PROPOSAL FOR CORRIGENDUM TO PROPOSAL TO DEVELOP AMENDMENTS TO  
GLOBAL TECHNICAL REGULATION NO. 9 (PEDESTRIAN SAFETY)  
(ECE/TRANS/WP.29/GRSP/2010/2)  
BASED ON THE 11<sup>TH</sup> FLEX-TEG MEETING RESULTS

Note: The text reproduced below was prepared by the expert from Japan in order to propose a corrigendum to proposal to develop amendments to global technical regulation No. 9 (ECE/TRANS/WP.29/GRSP/2010/2) to reflect the 11<sup>th</sup> Flex-TEG meeting (April 2010) results. The modifications to the proposed amendments to global technical regulation No. 9 (ECE/TRANS/WP.29/GRSP/2010/2) are marked in bold or strikethrough characters.

Figure 17: FlexPLI; instrument locations »

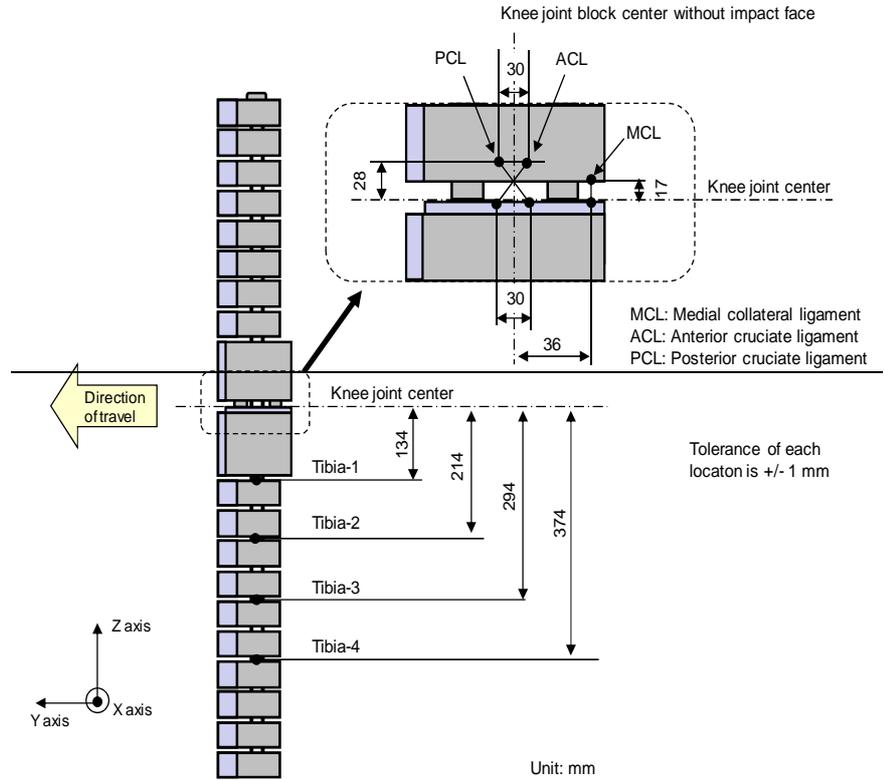
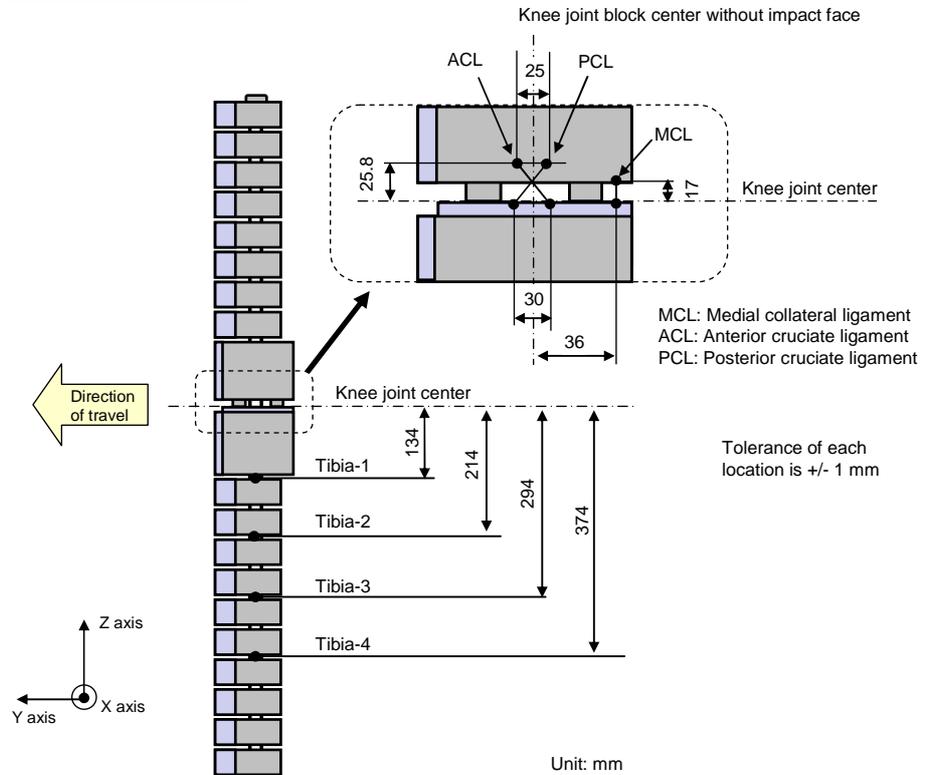
Figures 17., amend to read:
